ADDENDUM NO. 1
June 22, 2018

Trailer Dump Station and Fish Cleaning Station
Shadehill Recreation Area
Perkins County, South Dakota
GFP Project No. Shad19Pc; OSE# G2118--20X/DEL

Barracuda III 60139 Exterior Views	Scale: 1:32	FS60139-B3-E	Rev: 1A
Quality Machine & Manufacturing	Eng: JDB	Ckd: PJW	06/18/18

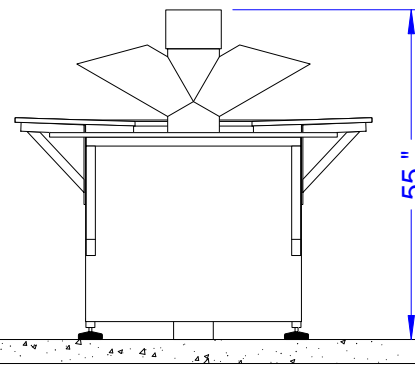
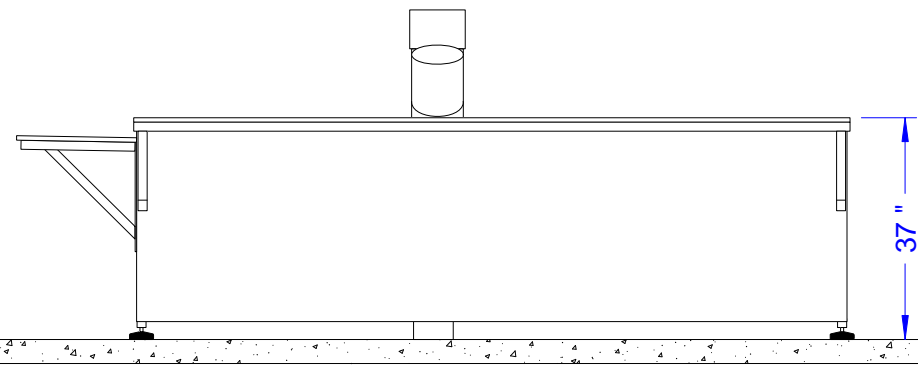
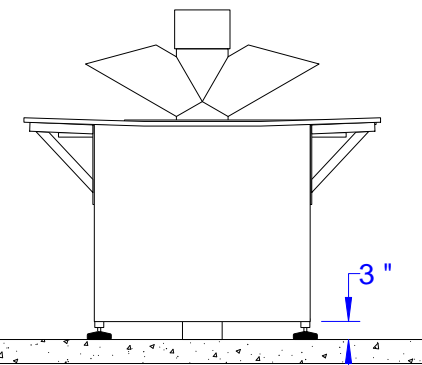
- Item No. 1: Reference Plan Sheets 32- 33. The attached drawings shall take the place of the drawings on Sheets 32-33 of the Plan Set.
- Item No. 2: SDR 7 -200 PSI HDPE waterline service piping is an approved alternate to schedule 40 PVC waterline service bid line items 1.16 & 1.17.
